PJM Manual 12: Balancing Operations v52 Revision Summary

M-12 Version 52 Revisions

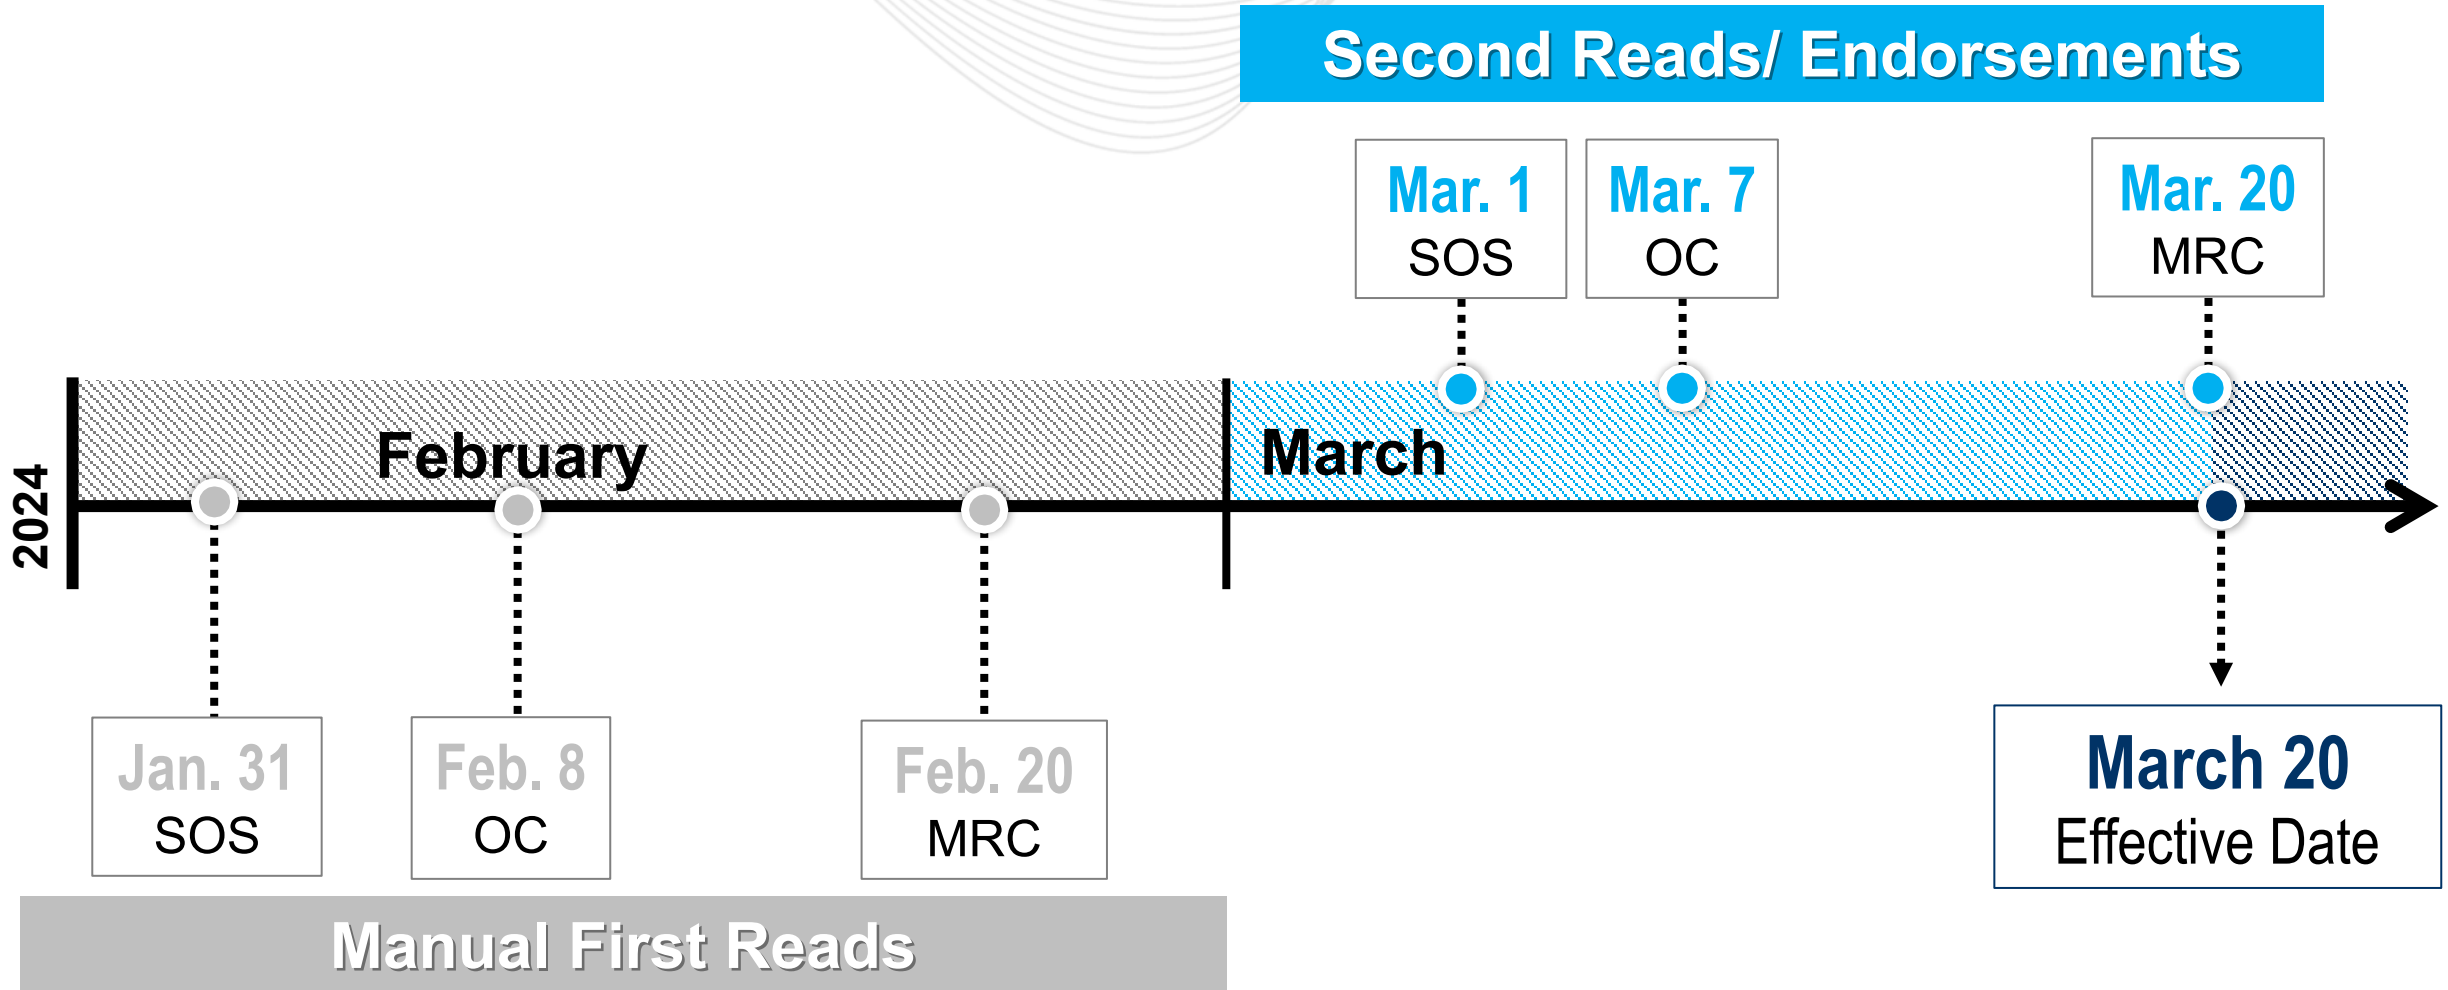
- Notes modified to include hybrid resources

3: An intermittent or hybrid resource's Economic Minimum shall represent the lowest operating MW point of the resource.

4: An intermittent or hybrid resource's Emergency Minimum should be set to 0.
